OAKS AT HAMPTON APARTMENTS

NEW LEASING CENTER AND MAINTENANCE GARAGE

**J2024-0157
PSP2024-0032
Revision #1
Received 10/17/2024**

Site Plan Review

Sheet No. :
G001

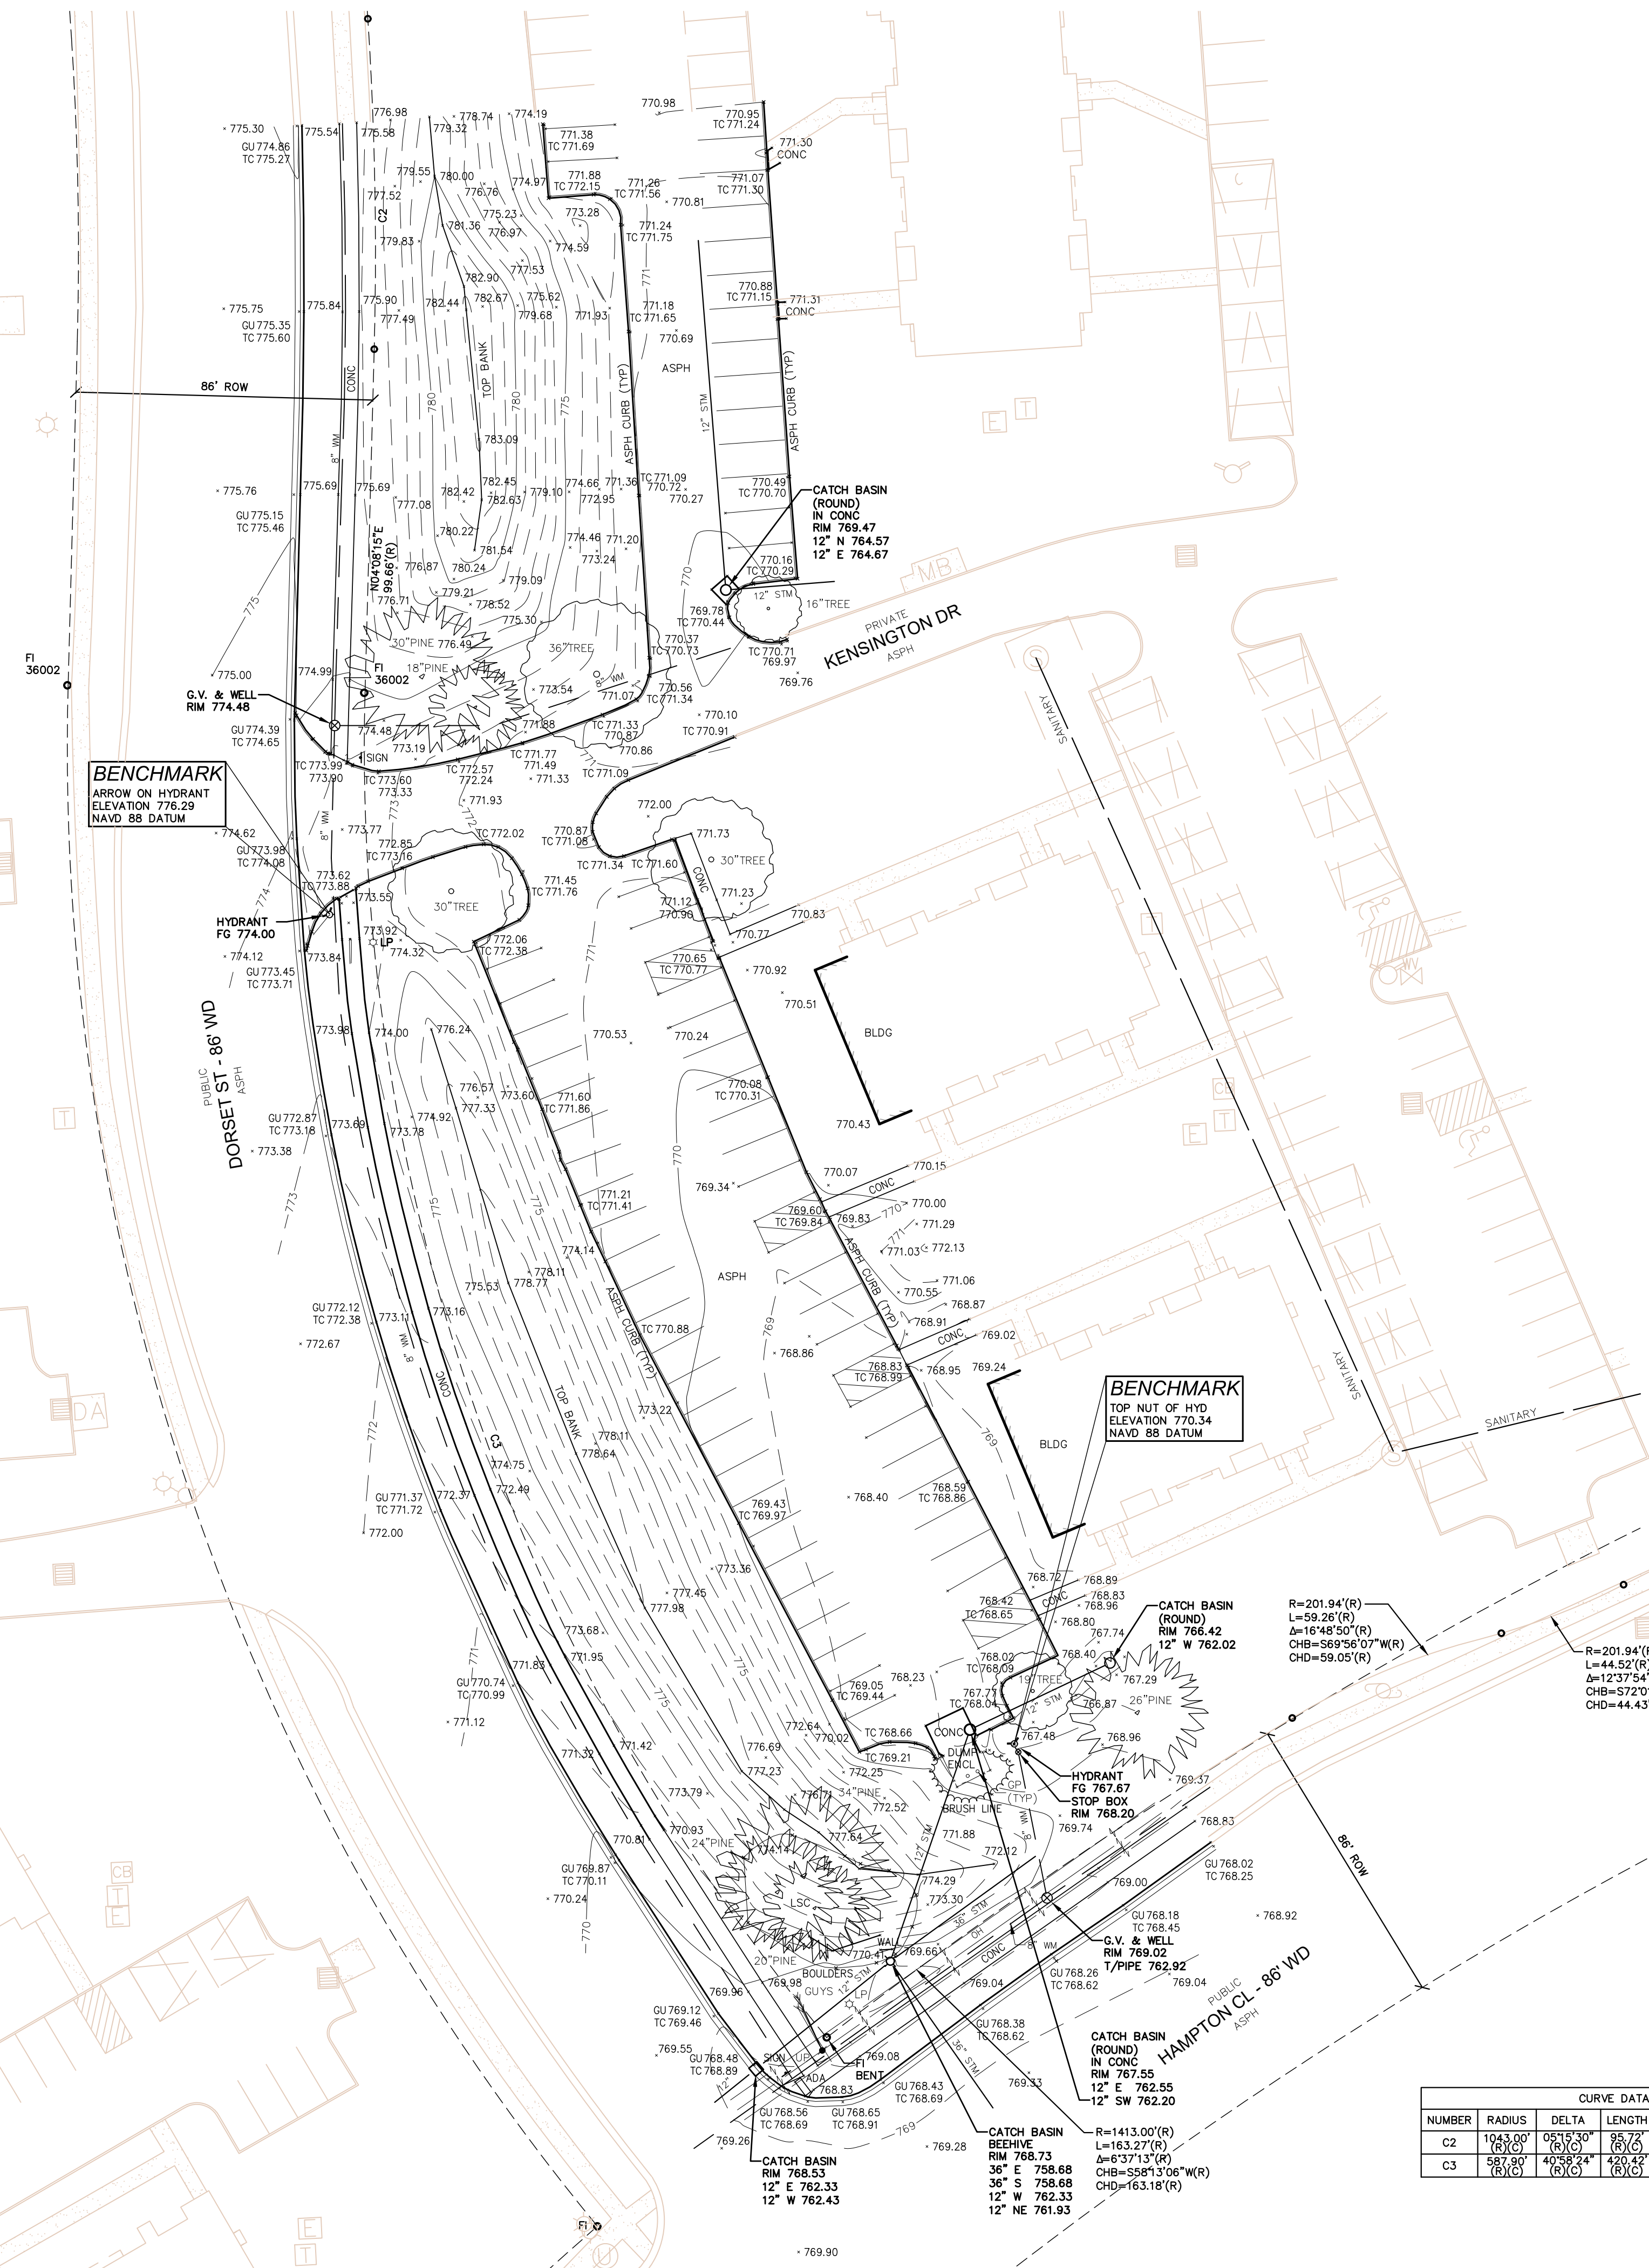
The WRC letter states that the construction plans will need to be submitted to their office for a drain review for a possible drain permit. The storm sewer design improvements will be determined by the WRC with that review.

The applicant will need to submit a Land Improvement Permit (LIP) application with engineer's estimate, fee and construction plans to proceed with the construction plan review process.
